Access Compliance Report Public Rights-of-Way (Curb Ramps)

Main Street: MAIN_ST Cross Street: N_ORANGE_OLIVE_RD Location: SE

ADA ID: RPAT210924143731 Ramp Type: Type 6 - Directional 1 Initial Pass/Fail: Pass Overall Compliance: No Severity Score: 5

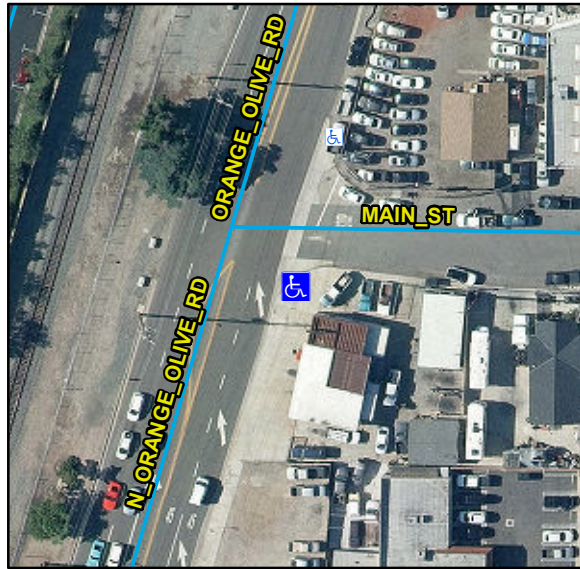
R304.5.2, R304.2.3, R304.5.4, R304.5.3, STD 1115

Compliance	Description	Data	Compliance	Description	Data
N/A	Ramp Length (in)	149	No	Flare Type LT	
Yes	Ramp Width (in)	51			Curbed1
Yes	Ramp Run Slope (%)	4.5	N/A	Flare Slope LT (%)	N/A
Yes	Ramp Cross Slope (%)	1.6	N/A	Flare Traversable LT	N/A
No	Grade Break	No	N/A	Flare Type RT	
N/A	Grade Break Slope (%)	N/A			Sloped
N/A	Grade Break Cross Slope (%)	N/A	Yes	Flare Slope RT (%)	4.5
	Addl Para Ramp Left?	No	N/A	Flare Traversable RT	Yes
	Addl Para Ramp Right?	No	Yes	DWS Provided	Yes
N/A	Landing Present	Yes	Yes	DWS Contrast	Yes
Yes	Landing Length (in)	61	Yes	DWS Length (in)	36
Yes	Landing Width (in)	90	Yes	DWS Full Width	Yes
Yes	Landing Run Slope (%)	2		DWS Offset Type	Multiple
Yes	Landing Cross Slope (%)	0.2	Yes	DWS Left Offset (in)	50
N/A	Landing Movement Obstructed?	No	Yes	DWS Right Offset (in)	0
	Landing Movement Type	N/A			
N/A	Landing Shared	No			
N/A	Marked Crosswalk 1	No	N/A	Clear Space	N/A
	Crossing 1 Direction	N	N/A	Clear Space To Crosswalk (in)	N/A

Marked Crosswalk 1 Width (in)	N/A			
N/A	Ramp Inside Crosswalk 1	N/A			
	Crossing 1 Slope (%)	2.8			
	Crossing 1 Cross Slope (%)	0.2			
Yes	Gutter Ponding	No	Yes	Curb Slope	7.8
Yes	Gutter Lip Height (in)	0		Road Run Slope (%)	N/A
No	Gutter Run Slope (%)	10.5		Road Cross Slope (%)	N/A
No	Gutter Cross Slope (%)	2.8		Parallel Ramp Side	Left
Yes	Overall Surface Condition	Acceptable	Yes	Perp Joint Present	Yes
	Cross Gutter Present?	Yes		Spandrel Present?	Yes
	Replace Cross Gutter?	No		Replace Spandrel?	No

Remove & Replace Entire Ramp. Remove & Replace Gutter.
